Re: SSD 6612 Martins Creek Quarry Project

I am writing to **object** to the above proposal. I believe that the Martins Creek Quarry Project should not be allowed to proceed as proposed for the reasons listed below.

Figure E.1 Historical Road Tonnages – 1993 to 2019

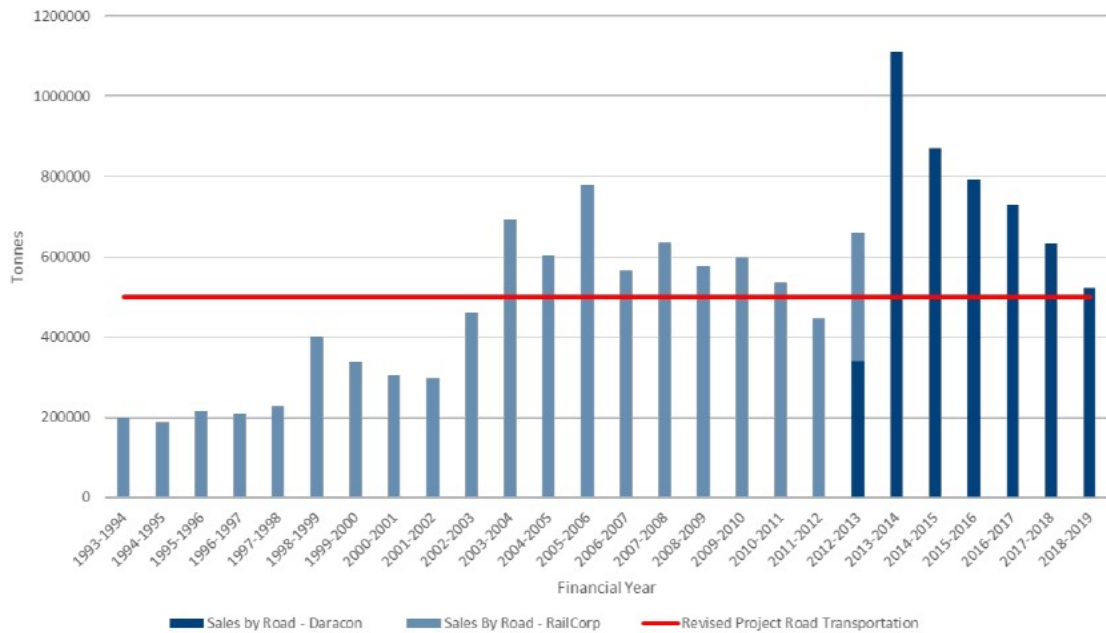
- The amended project proposes a reduction from a tonnage of 1.5 Mtpa to 1.1 Mtpa which implies a benefit to the community. When the quarry operated in 2013/2014 at the 1.1 Mtpa rate (see figure below) the impact to my family from traffic noise and vibration was substantial, to the point where we considered moving house.
